# Groundwater Transfer Review Summary Form

Transfer/PA # T- 13586

Application: T-13586

1. Basic description of the changes proposed in this transfer: T-13586 proposes to change the point of diversion (POD) on Certificate 43636 from a surface water diversion on the East Fork Nehalem River to an 80' deep groundwater point of appropriation (POA), located approximately 350 feet from the river. There is also a proposed change to character of use.

Figure 1. Well location map

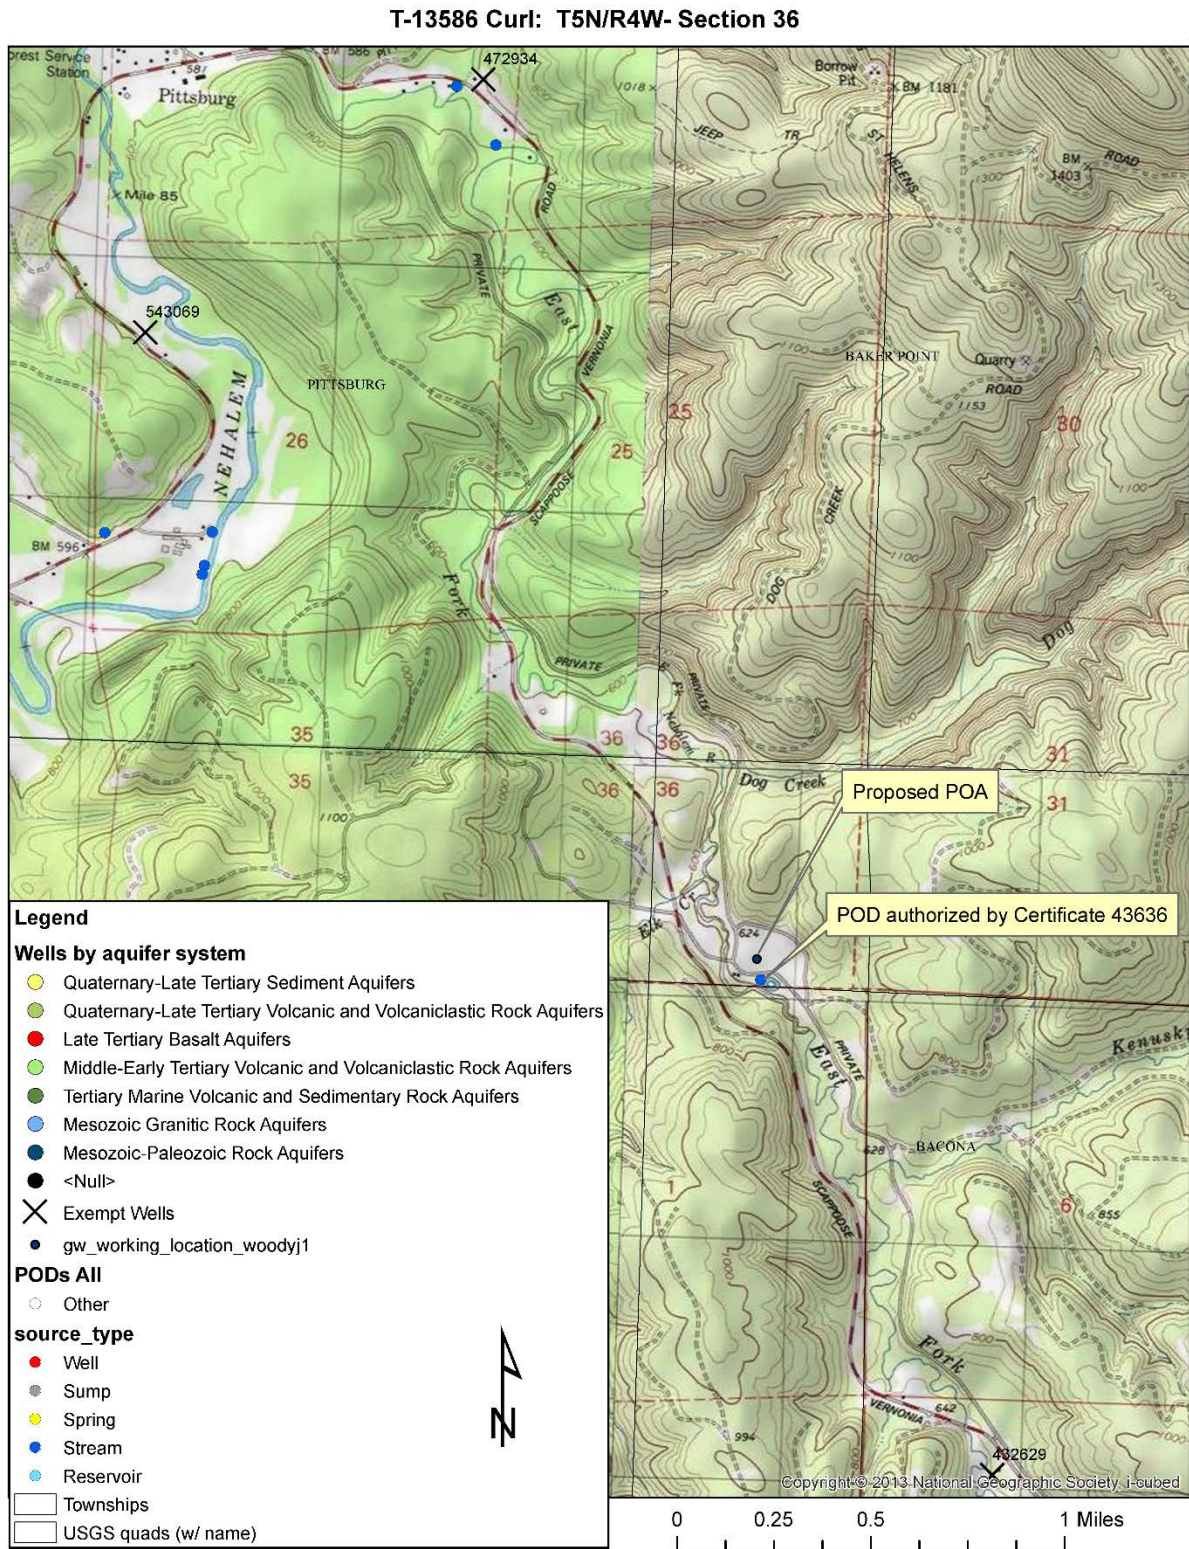
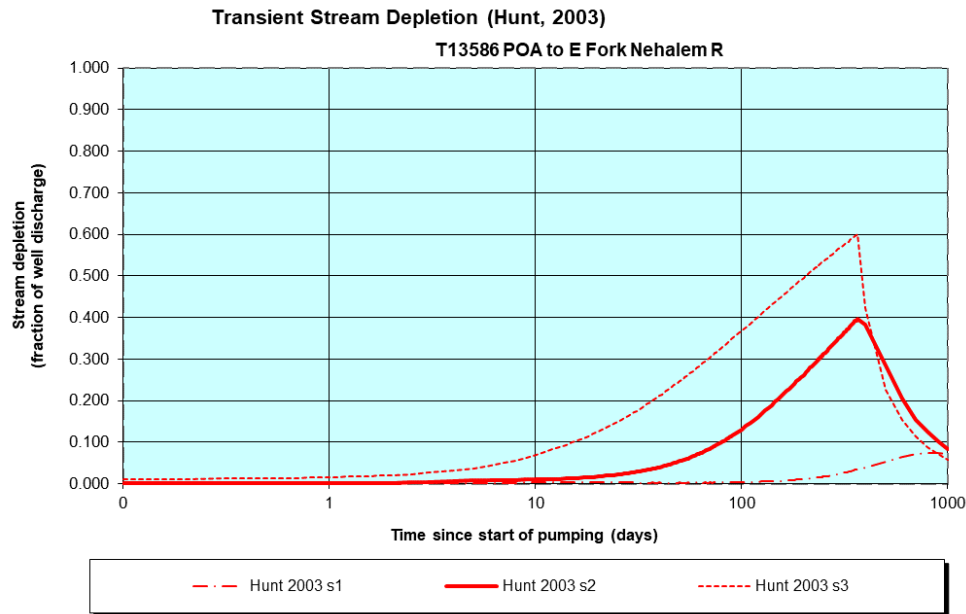
2. Will the proposed POA develop the same aquifer (source) as the existing authorized POA?  
 Yes     No    Comments: This is surface water to groundwater transfer, so feasibility per the rules hinges on source comments in Section 6. The "No" box is checked here to reflect the findings in Section 6. There are very few nearby well logs to reference. COLU 53803, located approximately 1 mile SE of the subject site is the closest. This well is located approximately 300 feet from East Fork Nehalem River and likely accesses similar geologic materials as the proposed well. COLU 53803 describes clay from 2- 27 feet below land surface, then sandstone and claystone. The first water-bearing zone is reported at 52 feet below land surface, with a static water level rising to 27.9 feet below land surface. COLU 54622, located approximately 2 miles to the north and adjacent to the river, reports 40 feet of clay overlying claystone and sandstone with the first water-bearing zone at 60 feet below land surface. This indicates the aquifer at the subject site is confined and likely composed of fractured marine sedimentary rocks of the Scappoose Formation.
